# Origination Form

## Proposed Revisions to a Standard Plans Index

<b>Originator:</b>	Turley, Joshua	<b>Index Number:</b>	460-470
<b>Date:</b>	5/7/2024	<b>Sheet Number(s):</b>	1,3
<b>E-mail:</b>	Joshua.Turley@dot.state.fl.us	<b>Index Title:</b>	TRAFFIC RAILING - (THRIE-BEAM RETROFIT) TYPICAL DETAILS & NOTES

### Summary of the changes:

TRAFFIC RAILING NOTES

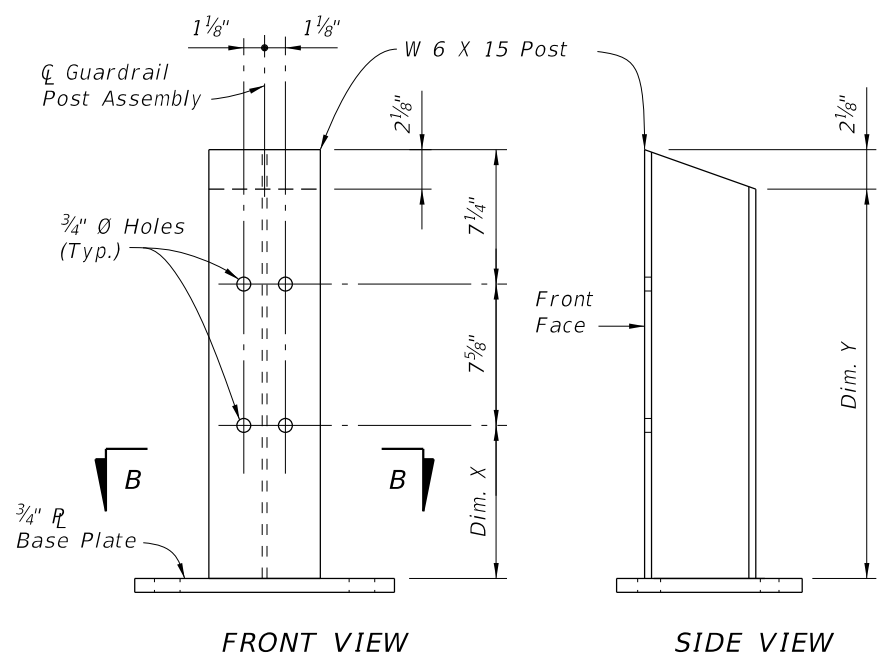
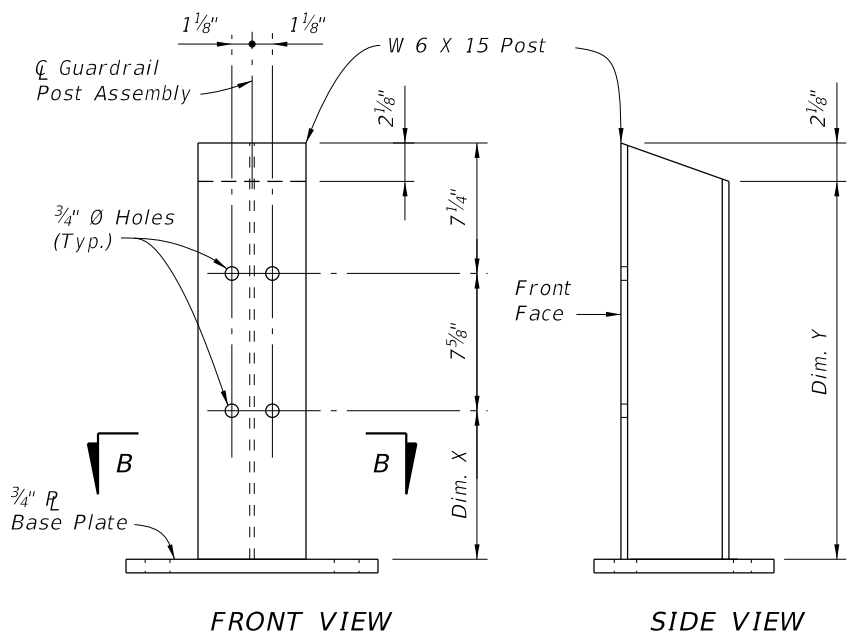
Sheet 1: Added screw anchor details to the notes.  
 Sheet 3: Added screw anchor option details to SECTION B-B

Upon completion of new research we are allowing screw anchors as an option as an alternative to adhesive anchors.

Screw Anchors shall meet the requirements for Developmental Specification Dev937PIAS

Screw Anchors shall be mechanically galvanized. All other

~~ADHESIVE-BONDED ANCHORS AND DOWELS: Adhesive Bonding Material Systems for Anchors and Dowels shall comply with Specification Section 937 and be installed in accordance with Specification Section 416. The field testing proof loads required by Specification Section 416 shall be 15,000 lbs. for 7/8" Ø anchor bolts; 55,000 lbs. for the 1 1/4" anchor bolts with 13" embedment; and 30,500 lbs. for the 1 1/4" Ø anchor bolts with 5" embedment.~~

SCREW ANCHORS: Screw Anchors shall be listed on the Innovative or Approved Products List (IPL or APL). No proof testing is required.

**ANCHOR BOLTS, NUTS AND WASHERS:** Screw Anchors shall meet the requirements for Developmental Specification Dev937PIAS. Adhesive-Bonded Anchors and Anchor Bolts shall be fully threaded rods in accordance with ASTM F1554 Grade 105 or ASTM A193 Grade B7. At the Contractor's option, Anchor Bolts for through bolting may be in accordance with ASTM A449. All Nuts shall be single self-locking hex nuts and in accordance with ASTM A563 or ASTM A194. Flat Washers shall be in accordance with ASTM F436 and Plate Washers (for long slotted holes only) shall be in accordance with ASTM A36 or ASTM A709 Grade 36. After the nuts have been snug tightened, the anchor bolt threads shall be distorted to prevent removal of the nuts. Distorted threads and the exposed trimmed ends of anchors shall be coated with a galvanizing compound in accordance with the Specifications.

**COATINGS:** Screw Anchors shall be mechanically galvanized. All other Nuts, Bolts, Anchors, Washers, Guardrail Posts, Anchor Plates and Base Plates shall be hot-dip galvanized in accordance with the Specifications. Guardrail Post Assemblies shall be hot-dip galvanized after fabrication.

**SCREW ANCHORS:** Screw Anchors shall be listed on the Innovative or Approved Products List (IPL or APL). No proof testing is required.
